**City of Portland, Oregon**  
**Bureau of Development Services**  
**Land Use Services**  
FROM CONCEPT TO CONSTRUCTION

## **NOTICE OF A TYPE II<sub>x</sub> DECISION ON A PROPOSAL IN YOUR NEIGHBORHOOD**

### **CASE FILE NUMBER: LU 14-253755 LDS**

#### **Proposal:**

RECEIVED  
FEB 18 2000  
14-253755  
C.3

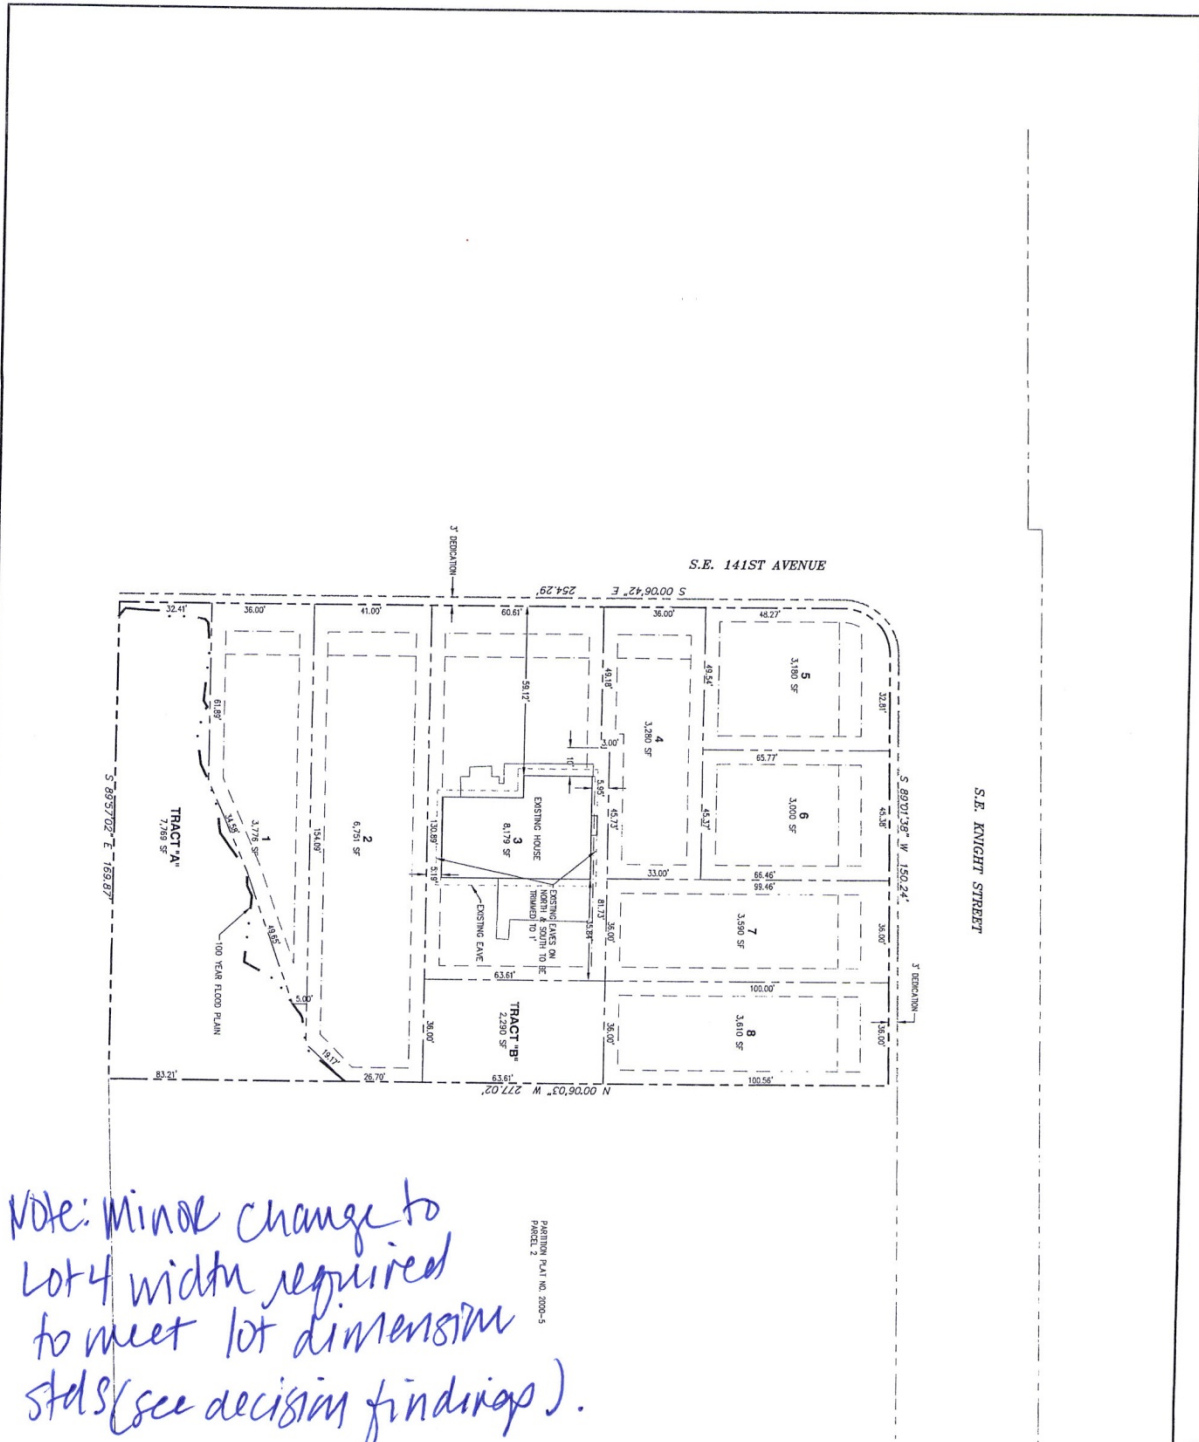
The findings above show that the applicable density and lot dimension standards are met. It should be noted that a minor revision to the Lot 4 dimensions are required to comply with the minimum width standard of 36 feet measured at the minimum front setback (10 feet) and 40 feet back. The applicant's plans show a small jog in the lot line at 49.18 feet. The side lot line must be straight for at least 50 feet to meet the minimum width requirement. There is flexibility to make this adjustment between Lots 3 and 4 on the final plat, as noted on Exhibit C.3. This criterion is met.

Note: Minor change to Lot 4 width required to meet lot dimension stds (see decision findings).
